SERVICE LETTER NUMBER 119			
TITLE: Reposition elevator down spring attachment tab			
BY: KMT	AIRCRAFT MAKE/MODEL(S):	FLOAT MODEL(S):	NOTE(S):
APP: KMT	Quest Aircraft Co.	7000S or 7000A	<b><u>MANDATORY</u></b>
DATE: 30-Mar-11	Model 100 Kodiak		<b><u>COMPLIANCE</u></b>
REV: A

All Quest Aircraft Co. Model 100 Kodiak aircraft equipped with Wipline 7000S or 7000A twin seaplane or amphibious floats, and also equipped with downturned exhaust ducts and/or exhaust deflectors listed on Wipaire installation drawing 1004690 or 1004683.

SERVICE LETTER P/N: 1005265 for ECO 22339

Fig. 2 – Fastener replacement and addition  
Spring attach angle shown clocked in correct position, with additional fastener  
Looking starboard from center

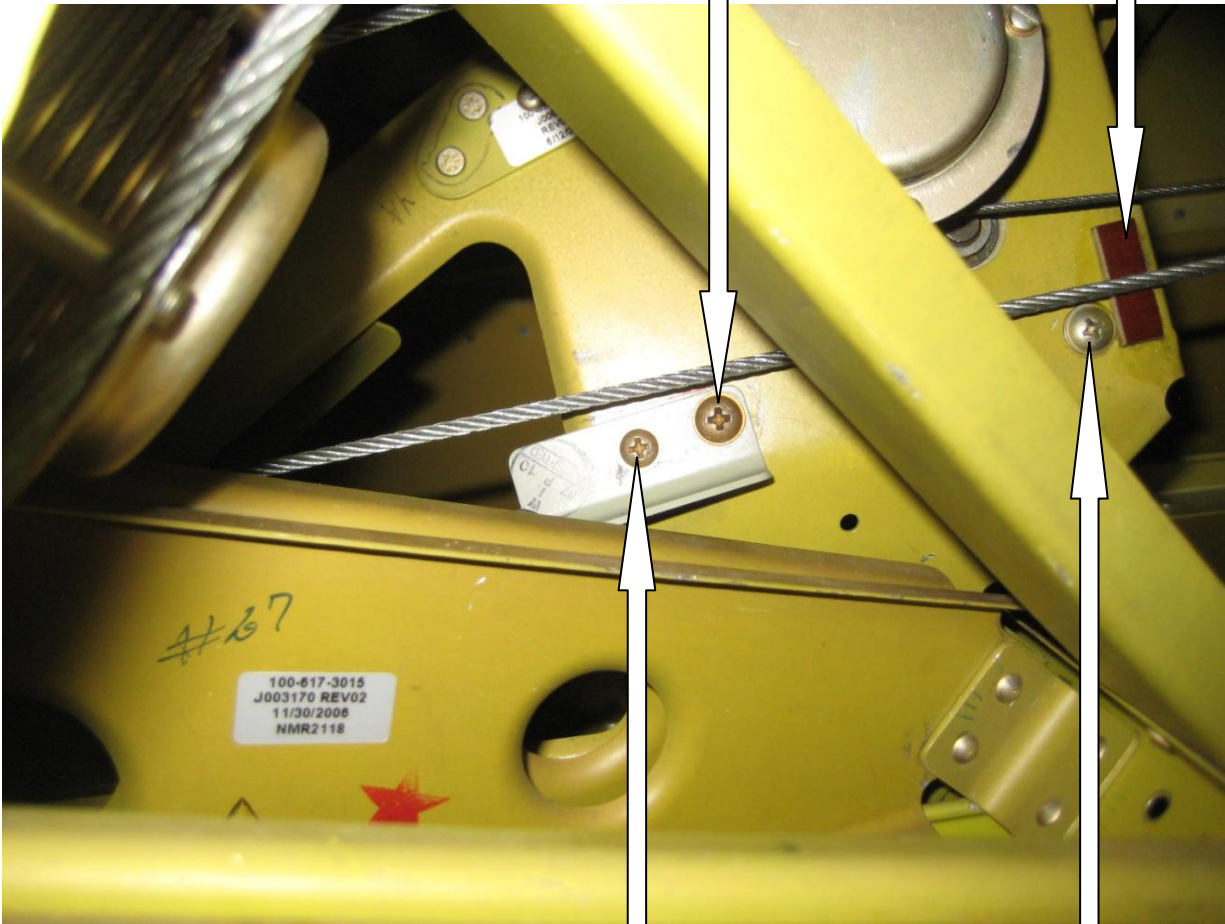
Change hardware:  
Screw, AN525-1032R10  
Washer, NAS1149F0363P  
Nut, MS21044N3

Add 1/8" thick 1" X 5/16"  
phenolic, bond to bracket  
with 3M DP190 adhesive  
(Note 1)

Add hardware:  
Screw, AN525-832R8  
Washer, NAS1149F0832P  
Nut, MS21044N08

Change hardware:  
Screw, AN525-1032R8  
Washer, NAS1149F0363P  
Nut, MS21044N3

10. After correct positioning has been determined Match drill a #17 hole through the angle and autopilot clutch bracket.
11. Finish hardware installation as shown in figure 2. A screw is added to retain the angle to the auto pilot clutch bracket and two bolts are replaced with washer head screws to increase cable clearance.

12. Add a piece of phenolic bonded to the auto pilot clutch bracket at the location and size shown in figure 2. Bond the phenolic to the clutch bracket with 3M DP190 or equivalent adhesive. This is not a structural bond.

Fig. 3 – Clearance between elevator spring and cable after modification  
Looking starboard from center

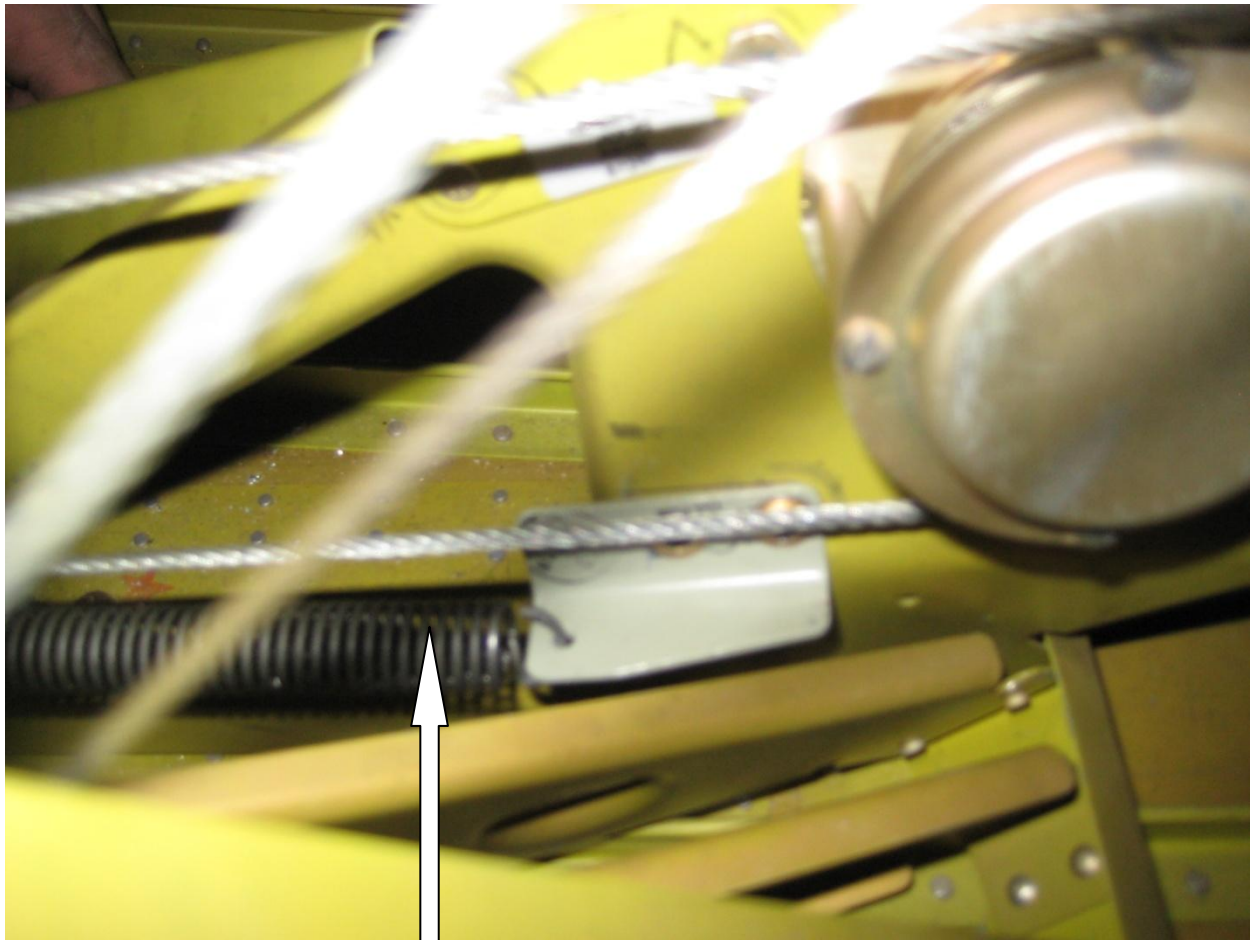
Proper gap between spring and cable shown, as determined by hole locations in figures 4 and 5. Clearance between spring and cable must be 1/8 inch minimum at forward end of spring.

Fig. 4 –Additional hole in auto pilot clutch bracket  
This hole will align with the additional hole in the attach angle P/N 1004687.  
Looking starboard from center

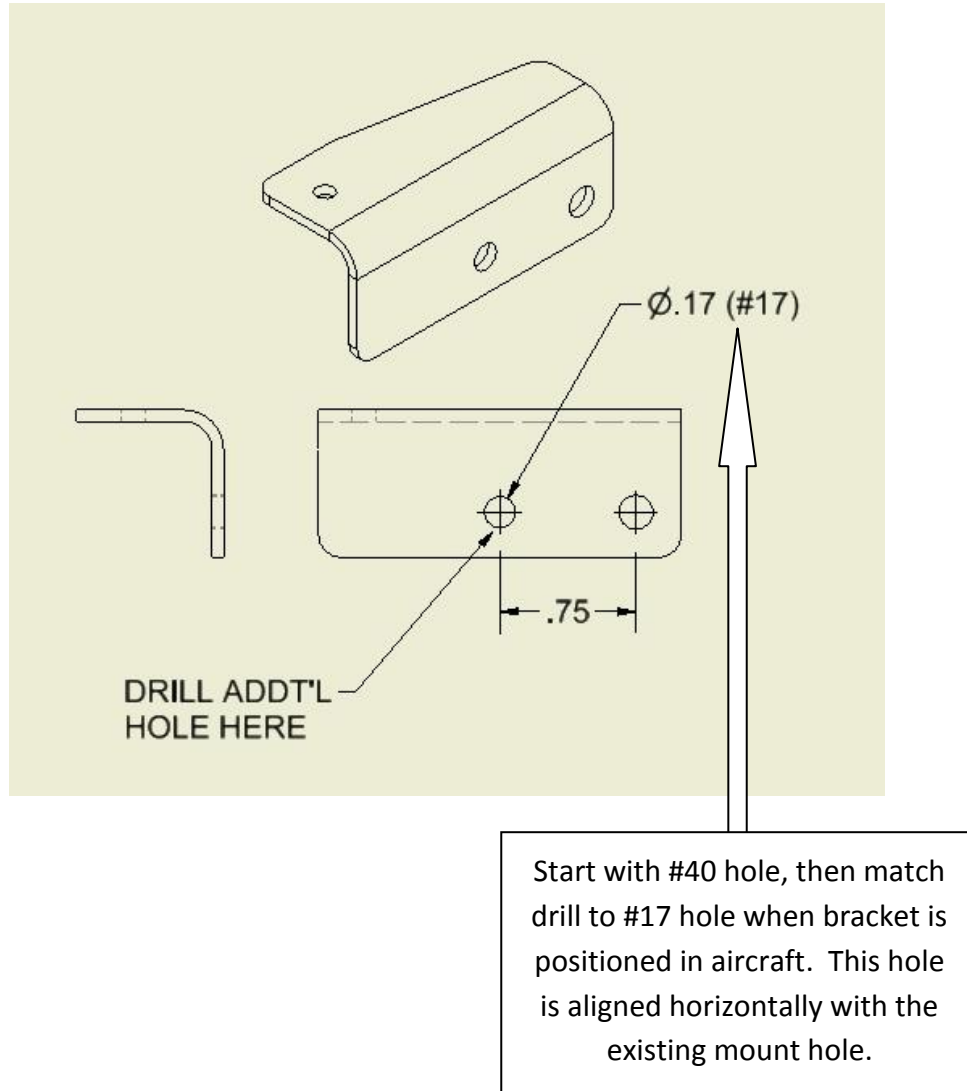
Measure 3 inches down from the rivet head, parallel with the bracket edge, and then draw a line here at the end of scale. This line will coincide with the center of the additional hole in figure 5.

Fig. 6 – Bridle hardware clearance and orientation  
Looking port from center

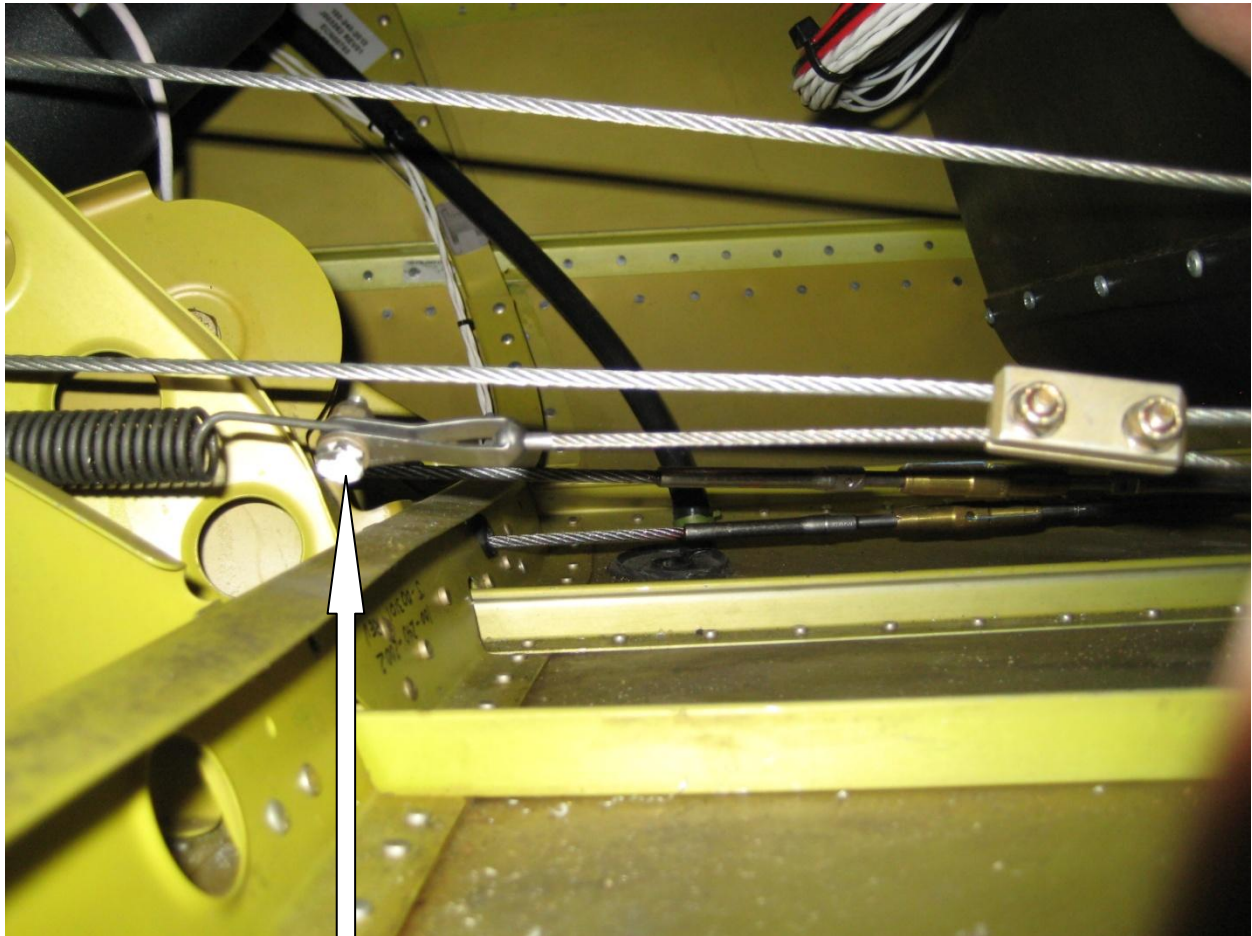
Ensure there is 1/8 min clearance between bridle hardware and cable. Bolt direction may be swapped to increase clearance if required.

9. Temporarily connect the spring and measure clearance between the spring and bridle hardware and the elevator cable. Clearance should be 1/8 inches minimum. Make sure to check clearance with the bridle hardware *and* spring body. See figure 6. If clearance is inadequate, the angle may be rotated slightly (pitch down).
